Notice of Electro-Magnetic Switch Change (S-KR11→S-CR11)

Subject	Notice of Electro-Magnetic Switch Change (S-KR11→S-CR11)	Date of issue	March 12, 2014	Notified to
		MITSUBISHI ELECTRIC FA INDUSTRIAL PRODUCTS CORPORATION 1-1-1 Imajuku-Higashi, Nishi-ku, Fukuoka 819-0192 TEL 092-805-3400		Sales agent

S-KR11 (Before change)	S-CR11 (After change)
Appearance		
Overall size (length×side×high)	68.6 × 82 × 94.5	64 × 82 × 88.5
Attachment pitch (length×side)	50 × 73 (2-M4 screw)

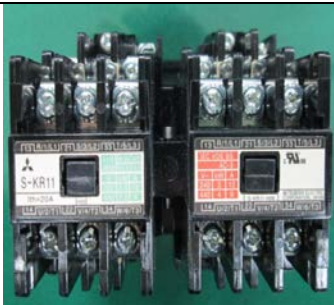
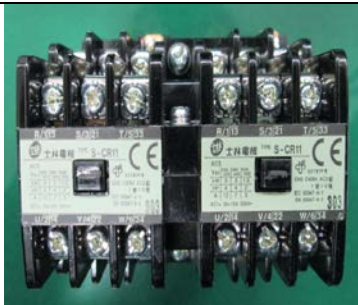
Change Electro-magnetic switch S-KR11 (manufactured by Mitsubishi Electric Corporation) to S-KR 11 (manufactured by ShihLin Electric Corporation).

Part Name of Electro-magnetic switch		Part Code		Compatibility	Overall size and Outward
Existing Product	Switching Products	Existing Product	Switching Products	Compatible	See below
S-KR11	S-CR11	03G30T	03G32G

- The acceptance of order on 15th April 2014, or after.
- Service parts : After S-KR11 (03G30T) is out of stock.
